* INTERIOR COLOUR SCHEME *

CONSTRUCTION SUMMARY

Forestside Estates Inc.

LOT NUMBER	PHASE	HOUSE TYPE	CLOSING DATE
49	8	WHITE ORCHID (45-05S4A)-ELEV A-STD MAIN-4 BED	27-Jun-24

KITCHEN SINK WALL

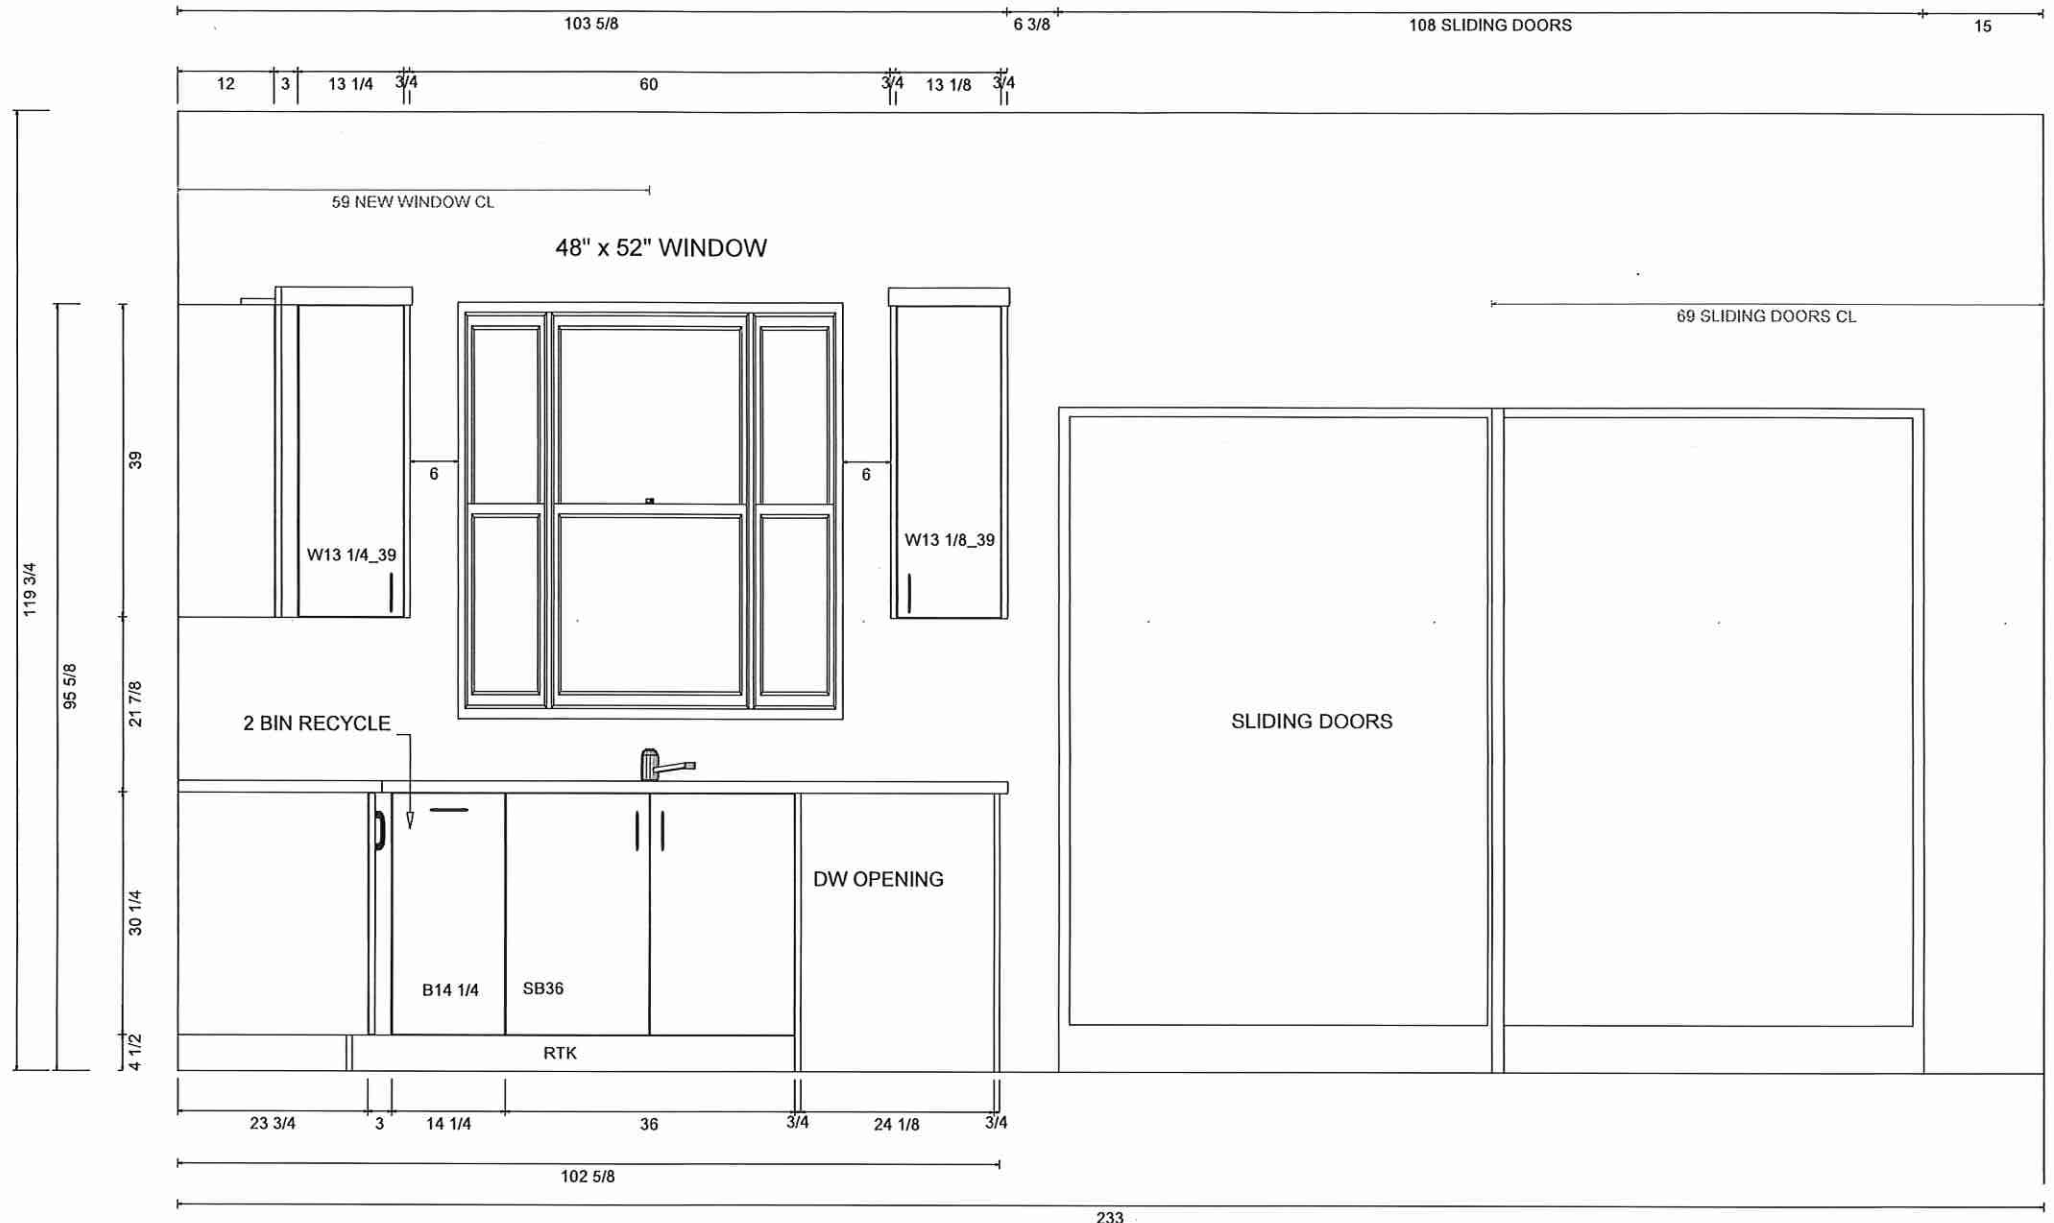
1 - KITCHEN- Relocate the builders standard 48"x52" window from side exterior elevation to rear wall elevation. To be isntalled above new sink location (See Sketch)

1 - KITCHEN- Relocate the sink and dishwasher to the rear of house under new 48"x52" window
